**From:** Karen Walter <KWalter@muckleshoot.nsn.us>  
**Sent:** Tuesday, July 9, 2019 8:09 AM  
**To:** Nick Holland  
**Subject:** RE: Updated NOA for L60 Culvert

**From:** Barry Baker [<mailto:bbaker@g-o.com>]  
**Sent:** Thursday, November 15, 2018 11:10 AM  
**To:** 'Fisher, Larry D (DFW)'; Karen Walter; 'McDermott, Kristin L CIV USARMY CENWS (US)'; 'Nick Holland'  
**Cc:** Neil Jensen  
**Subject:** Lake Forest Park L60 culvert replacement on Lyon Creek

Please see the responses to the comments provided by Karen Walter of the Muckleshoot Tribe. These comments and responses are applicable to the City of Lake Forest Park SEPA and PAUE process; Washington State Department of Fish & Wildlife HPA APPS submittal (APPS #14550); and USACE JARPA Submittal (NWS-2018-504). Our responses in in red italics following the original comment.

MUNICIPALITY OF METROPOLITAN SEATTLE  
LYNN AND MALCOLM CREEK TRUNK  
SYSTEM

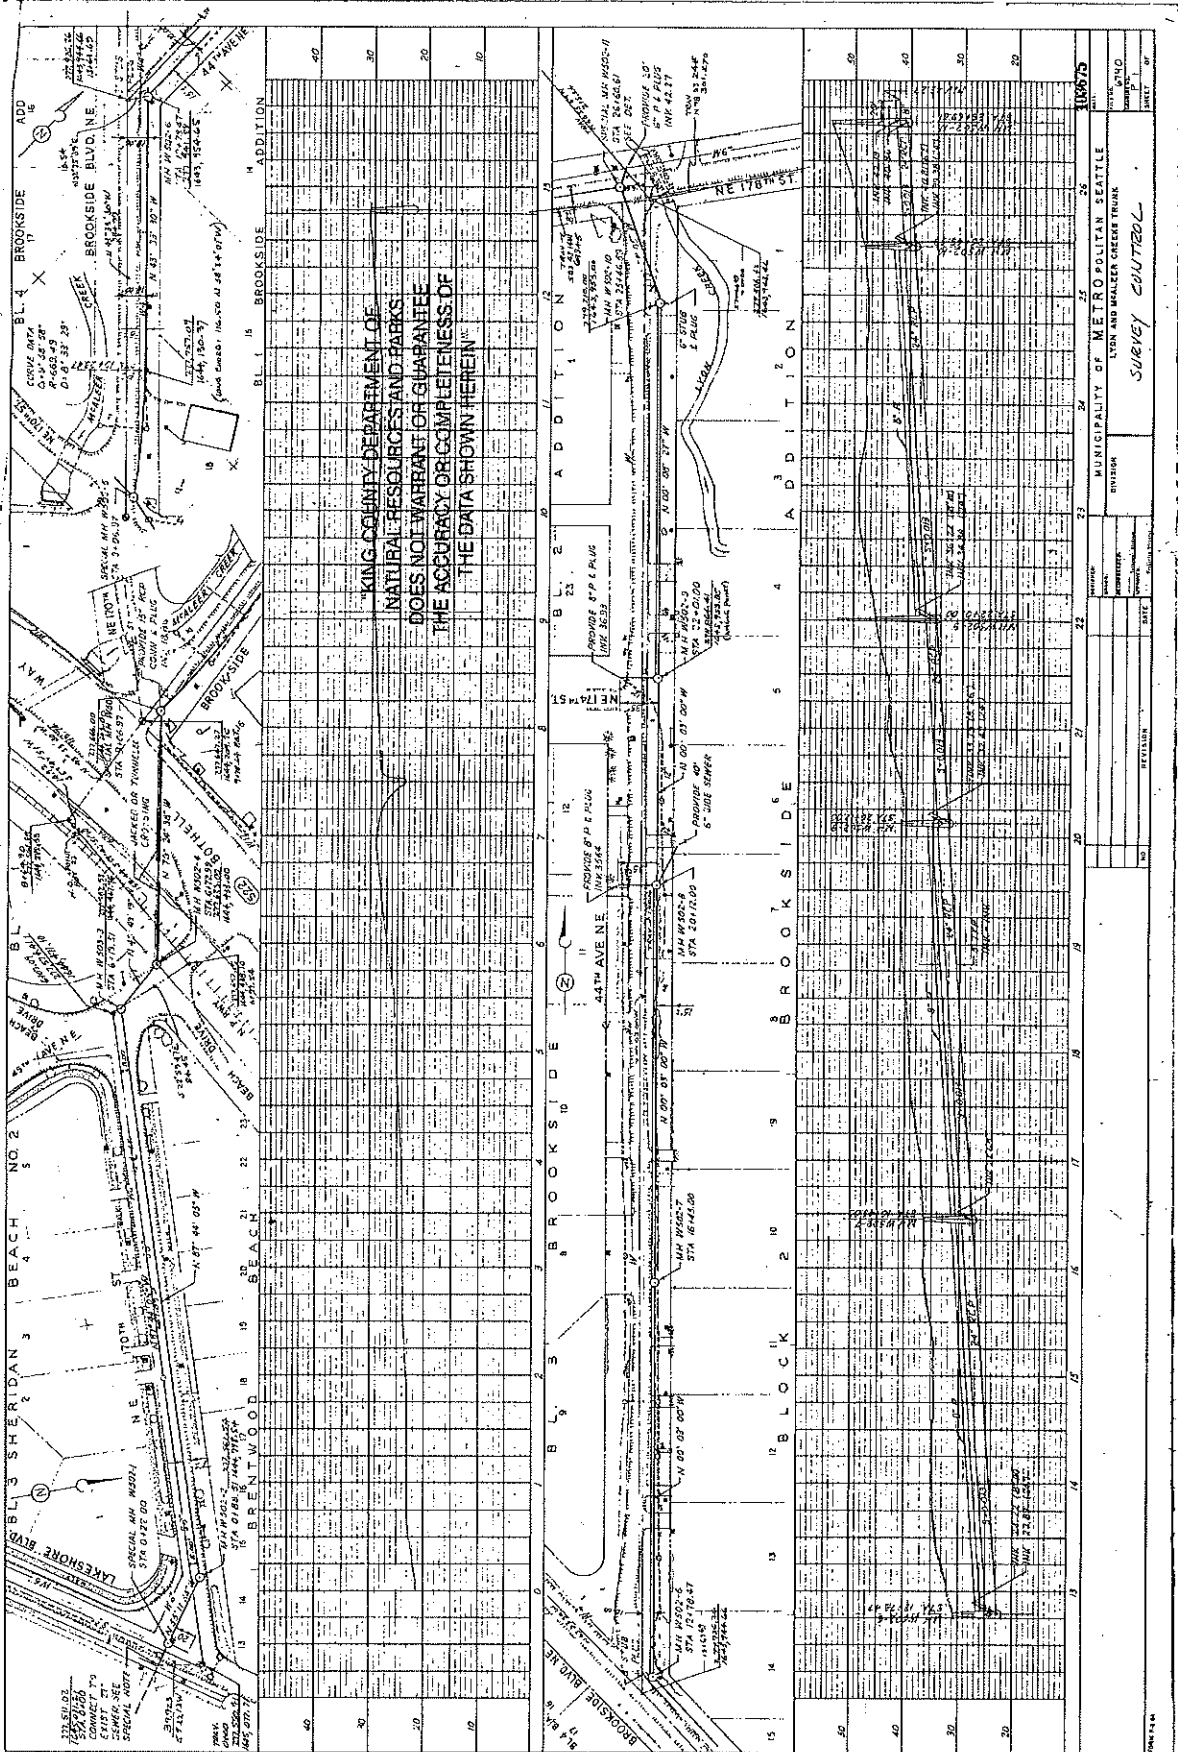
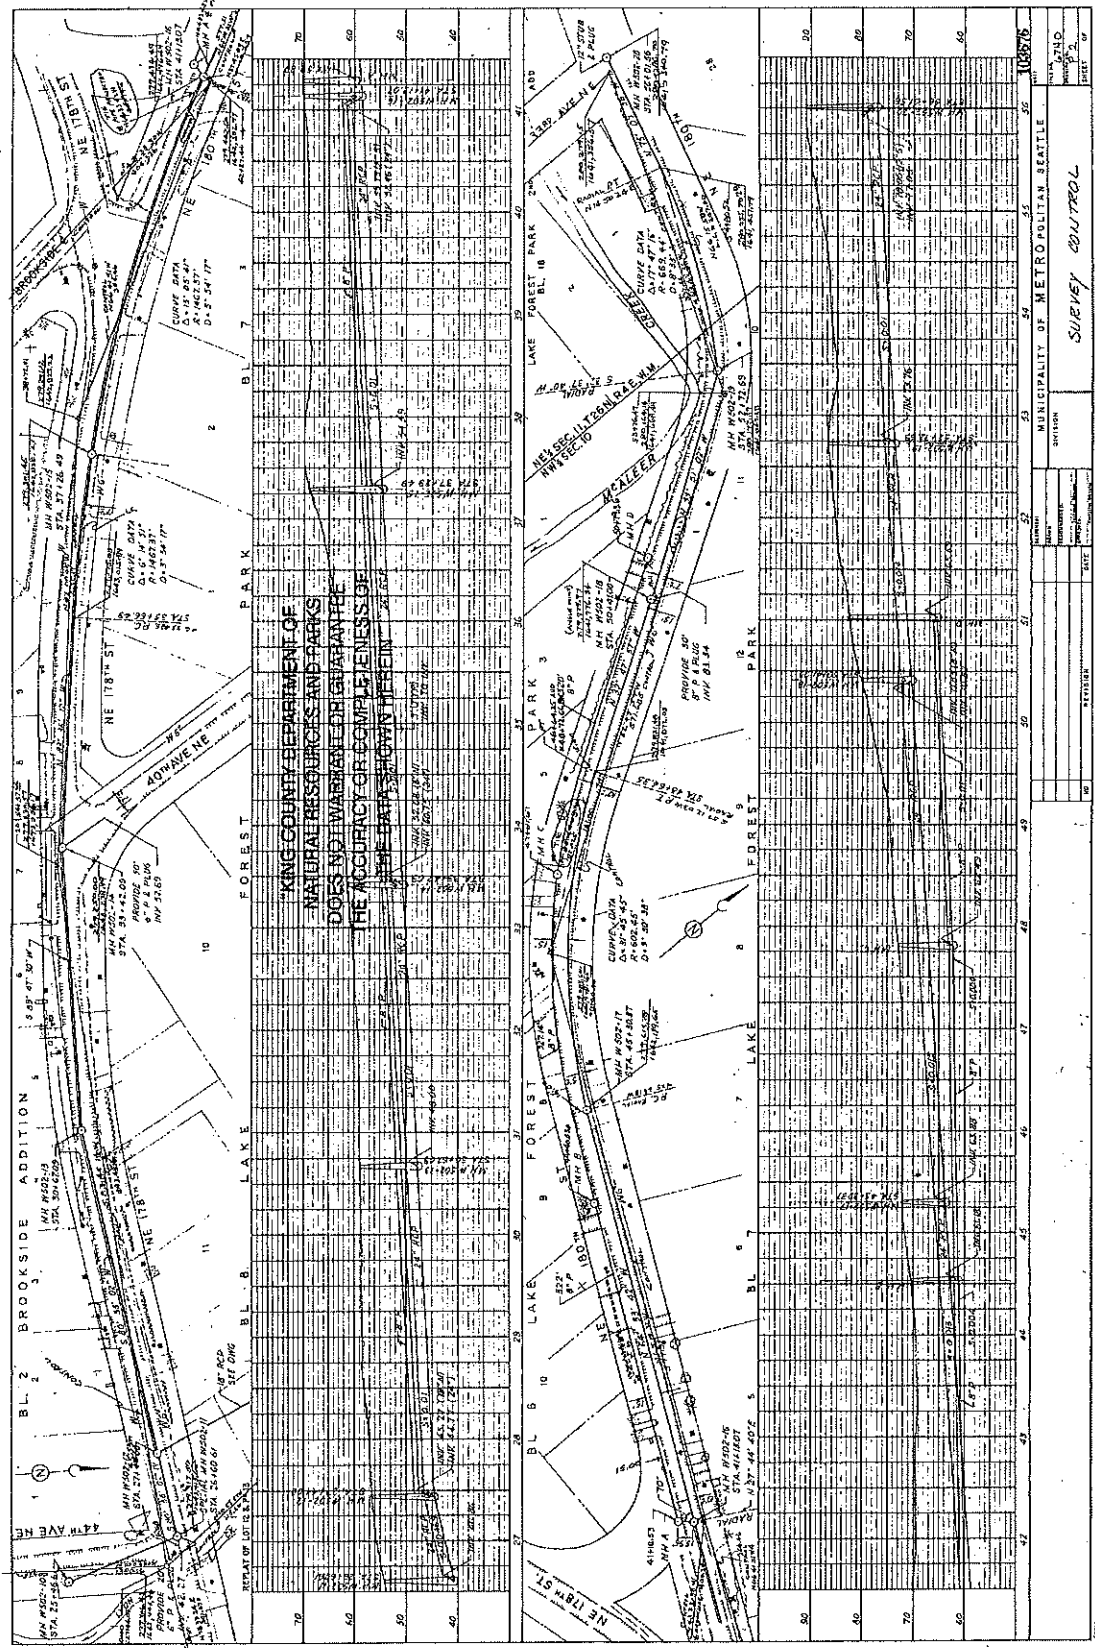
The King County Wastewater Treatment Division (WTD) has received the Notice of Application for Public Agency Utility Exception, File Number 2018-PAUE-0001. **Two King County facilities, the 24-inch diameter Lyon and McAleer Trunk sewers, are located near the project site. We have attached scanned record drawings showing the locations of these sewer pipes in the vicinity of the project area.**

In order to protect these wastewater facilities during construction, **WTD requests that the City submit construction drawings for the project**, so that WTD can assess its potential impacts. Please send drawings to:
